Staff Report

To: Salt Lake City Planning Commission
From: Michael McNamee, Associate Planner, michael.mcnamee@slcgov.com, 801-535-7226
Date: December 15, 2021
Re: PLNPCM202021-00663 – Grygar Accessory Dwelling Unit – 362 East Sherman Avenue

CONDITIONAL USE

ARCHITECTURAL SITE PLAN

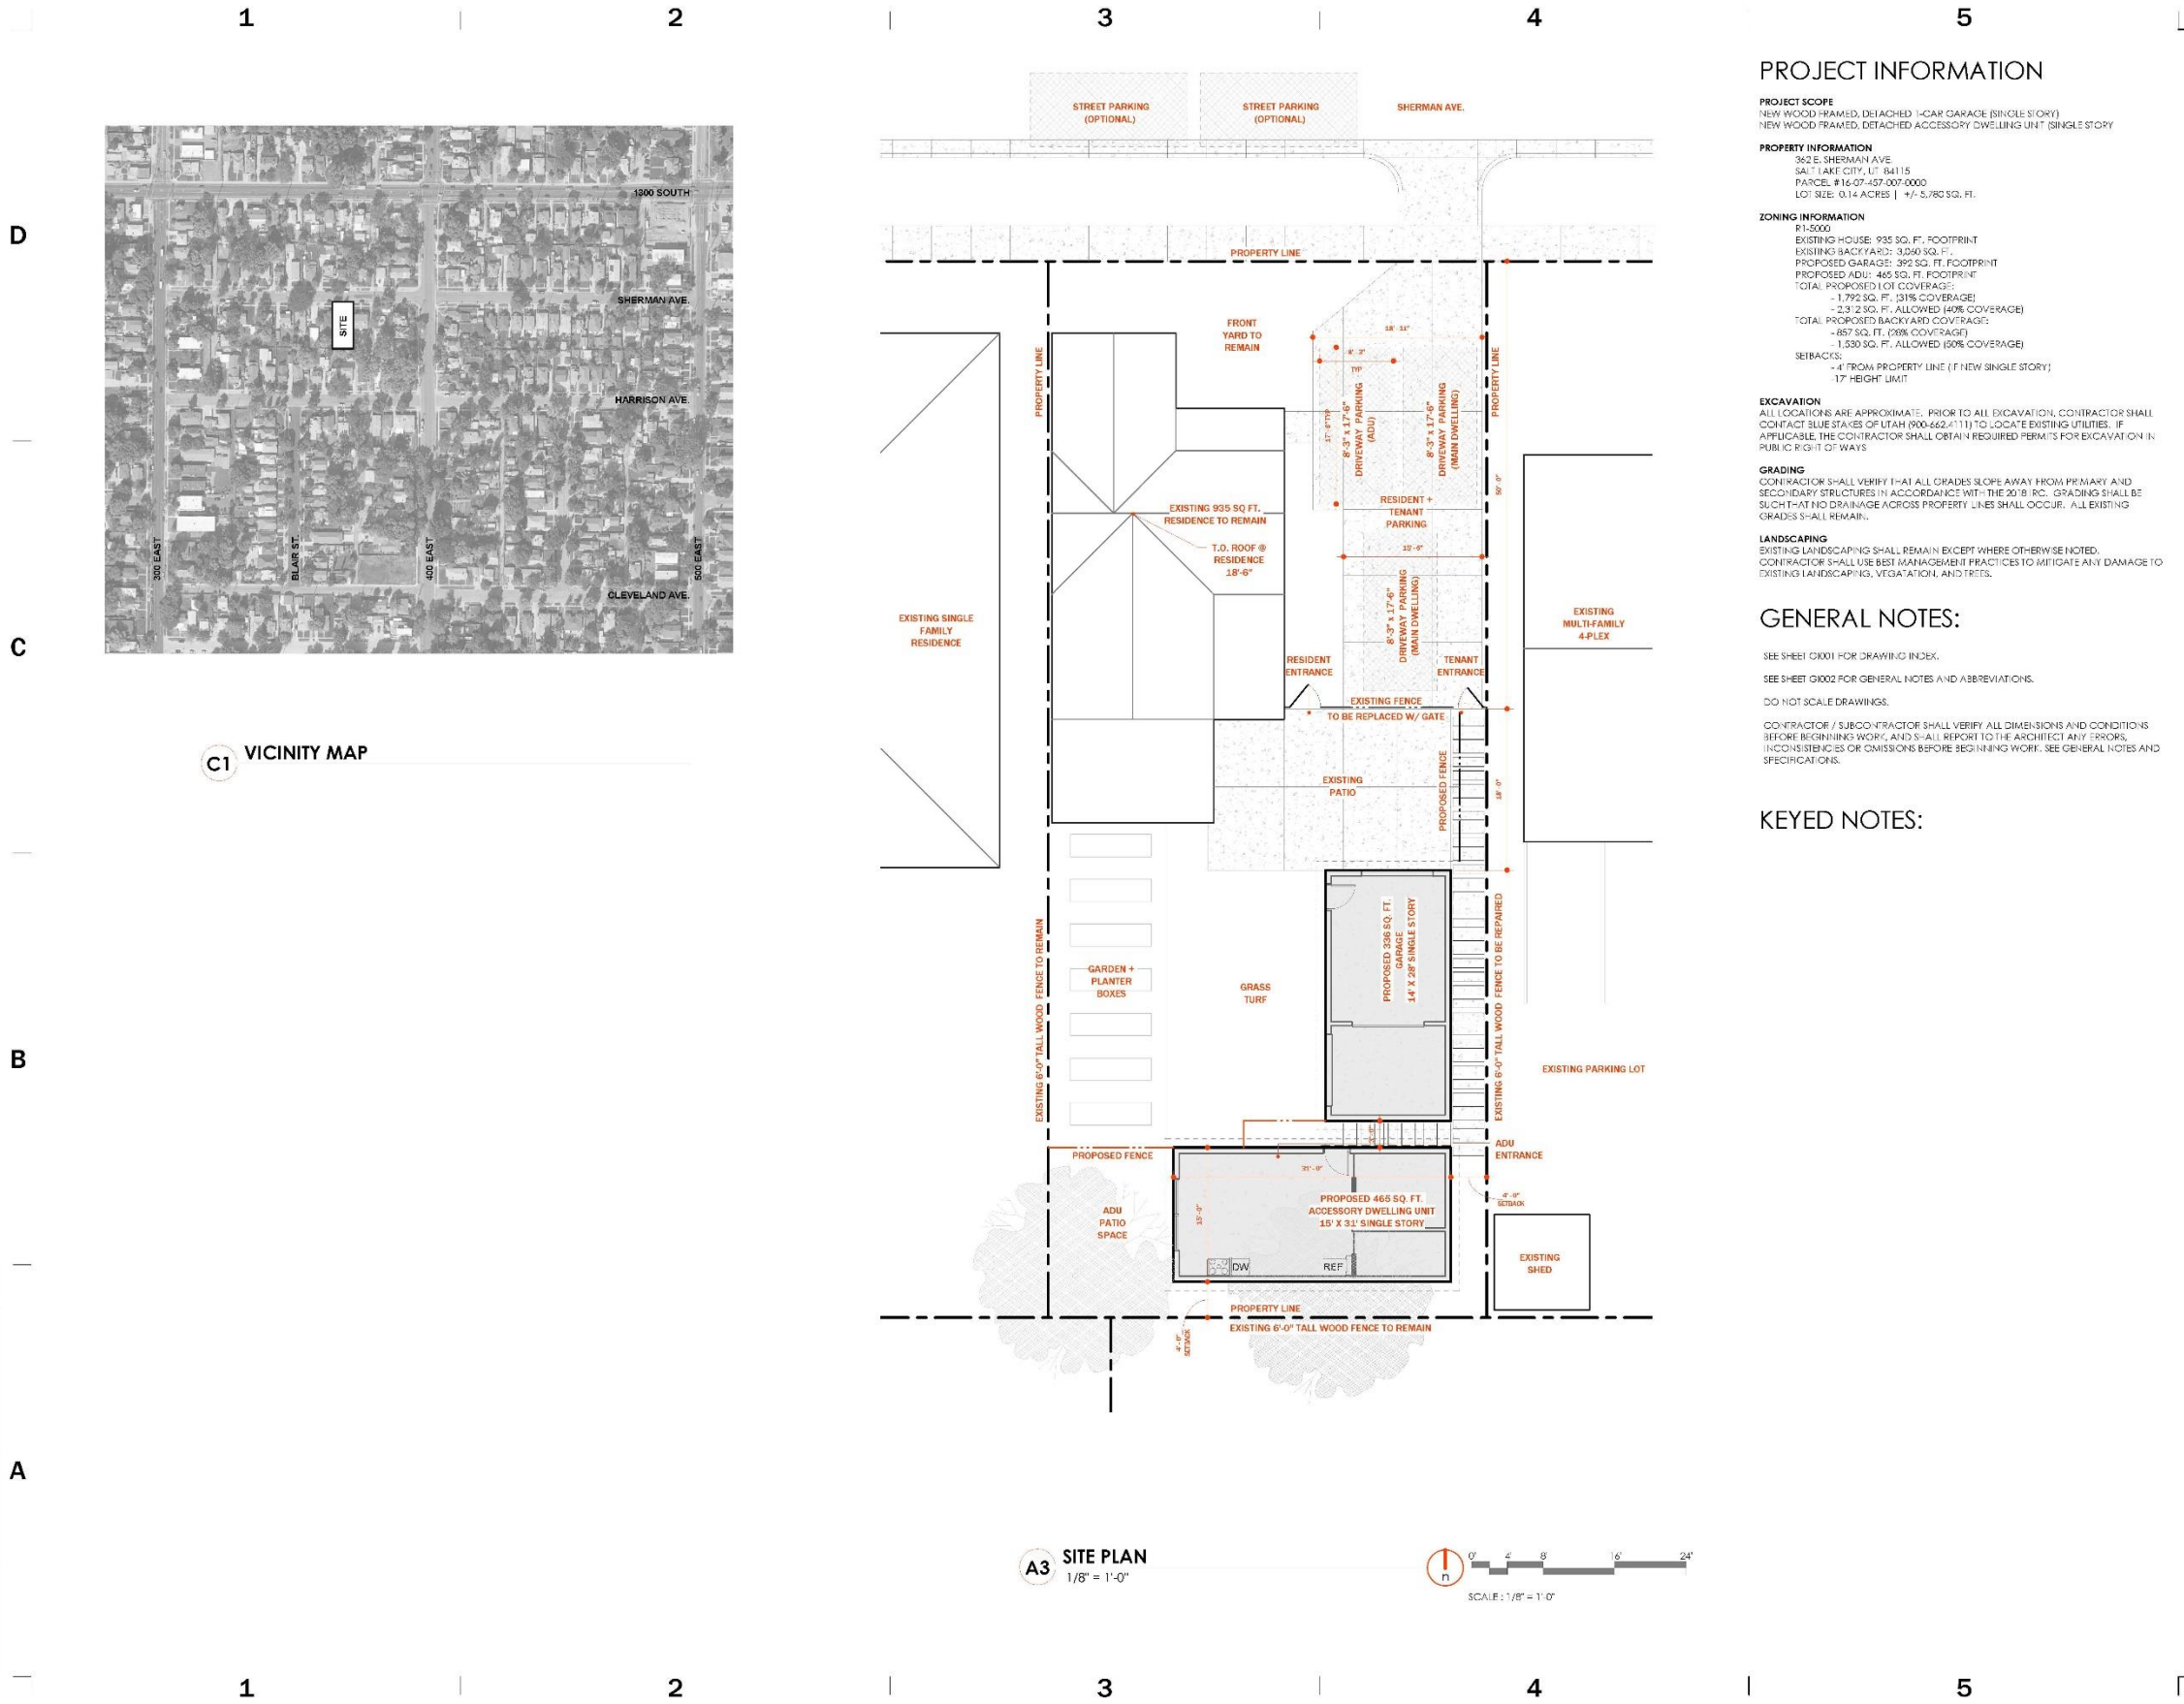
The applicant has proposed required parking for the ADU to be located on the property. However, the Transportation Division has noted that the parking configuration proposed, which is drawn to include three parking stalls, actually only has large enough dimensions to meet the requirements for two stalls. Two off-street parking stalls are required for the single-family dwelling, so the two stalls provided would not count towards required parking for the ADU. Alternatively, required parking for the ADU can be located on the street, which is permitted since there is parking available in front of the subject property (see [21A.40.200.E.1.g.\(1\)](#)). The applicant also has a second option to waive the off-street parking requirement because the property is located within ¼ mile of a transit stop ([21A.40.200.E.1.g.\(2\)](#)). As noted in the Transportation Division review comments, there are two bus stops located on 500 E between 1300 S and Sherman Avenue, one northbound and one southbound, within one quarter mile of the subject property.

I believe that this property is able to satisfy the parking requirements for its purposes but perhaps not as presented on the plans. The single family residence requires two off street parking spaces and the ADU requires one off street parking space. The two parking spaces for the single family residence can be provided as tandem parking spaces, which meet the minimum parking dimension requirements, in the driveway behind the face of the house. The parking space for the ADU can be waived (per 21A.40.200.E.1.g) if (1) Legally located on street parking is available along the street frontage of the subject property; or (2) The subject property is located within one-quarter (1/4) mile of transit stop. Both of these provisions can be met. There are two bus stops located on 500 E between 1300 S and Sherman Ave, one northbound and one southbound, within one quarter mile of the subject property. The northbound bus stop has a bus shelter which provides “insurance” that this bus stop will not be moved. I also want to point out that the detached garage does not qualify as having a suitable parking space per SLC standards because the vehicle projection (the length) of the parking area inside the garage is shown as sixteen feet four inches (16’ 4”) which is less than the minimum requirement of seventeen feet six inches (17’ 6”) per 21A.44.020.E. As a clarification, I did not review the plans in relation to the required locations of the ADU or garage in proximity to structures/buildings on abutting lots, I will let someone from Zoning or Planning comment on those requirements.

A2 ANNOTATED PLAN - LEVEL 01
1/4" = 1'-0"

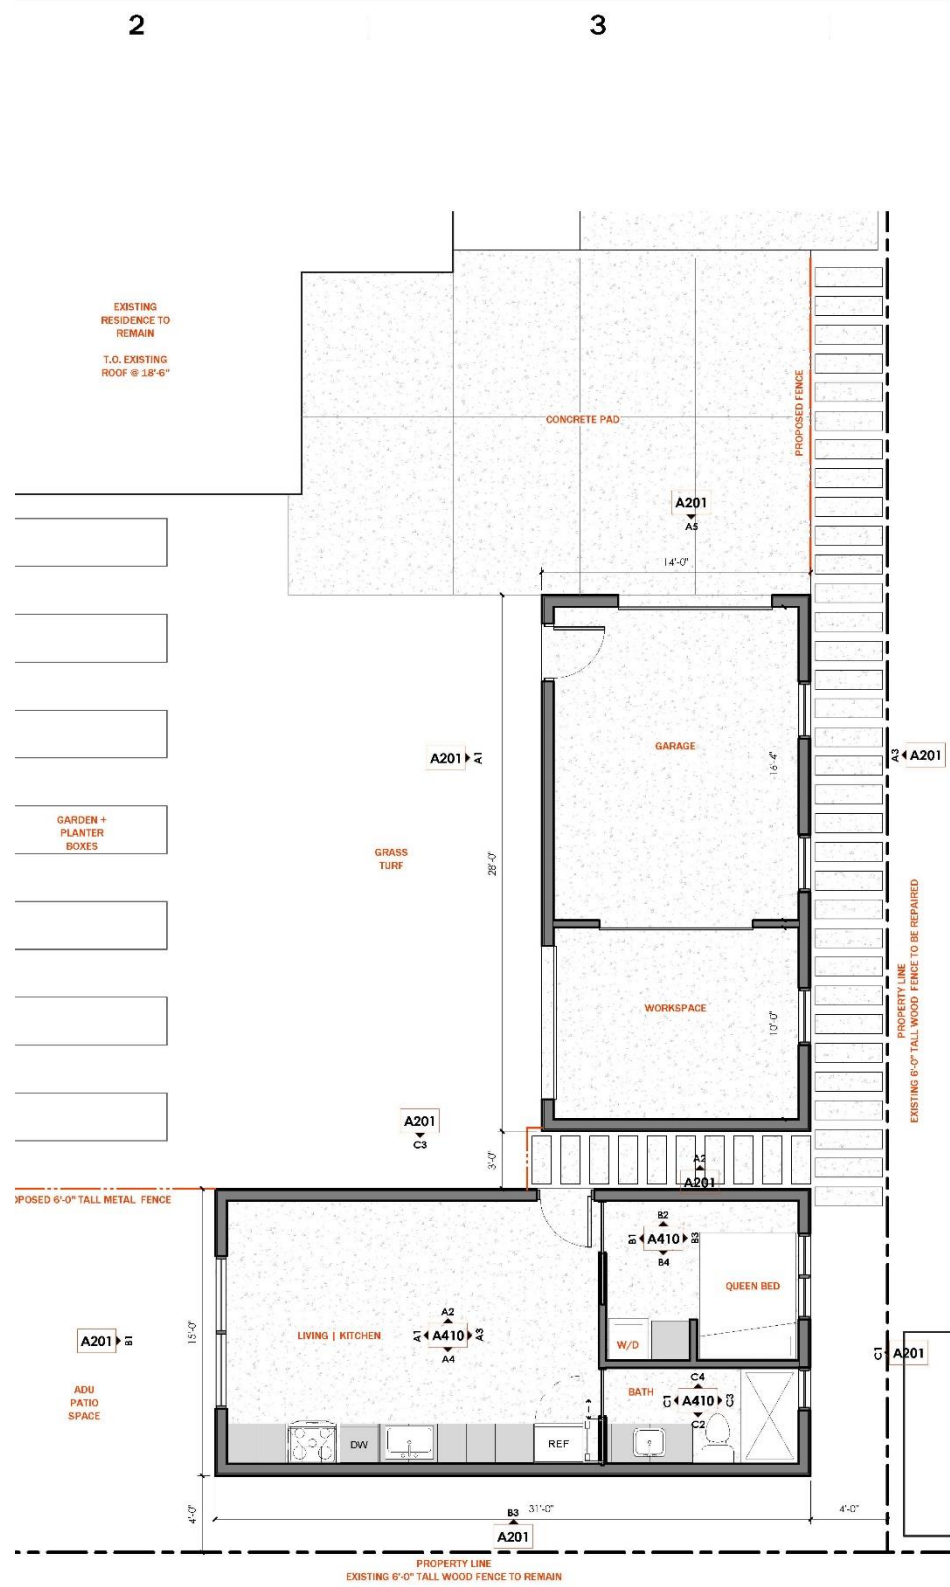
The proposed plan would be allowed as long as it meet the provisions set forth in Section R302 Fire-Resistant Construction. Specifically, TABLE R302.1(1) EXTERIOR WALLS. A one hour fire rated assembly is required.

Also, the design needs to follow the SLC accessory structure design standards. In this particular case it states “when a wall is less than 5’ but greater than or equal to 2’ from the property line, an eave may only extend to a point that is 2’ from the property line”

Finally the proposed opening in the kitchen area must meet the standards set forth in TABLE R302.1(2) for “openings in wall” within 4 ft.
